## JACKS AND PLUGS IDENTIFICATION AND SERVICE

1.001 This addendum supplements Section 461-630-100, Issue 10. Place this pink sheet ahead of Page 1 of the section.

1.002 This addendum is issued to add information on the 101A sleeve and to show the 43B bracket MD.

Fig. 32—63B Bracket With 101A Sleeve Installed

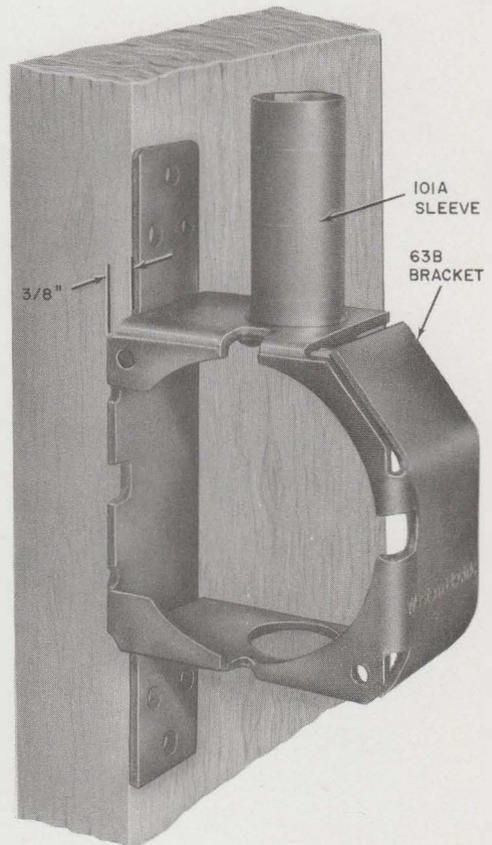
2.06.1 The 101A sleeve (Fig. 32) is used to protect the prewiring while the drywall is being cut around the 63B bracket as the drywall is being installed on the studding. The metal tube snaps into either access hole of the bracket before the wiring is placed.

2.002 On Page 20, Fig. 32 is obsolete. A new Fig. 32 is shown in this addendum.
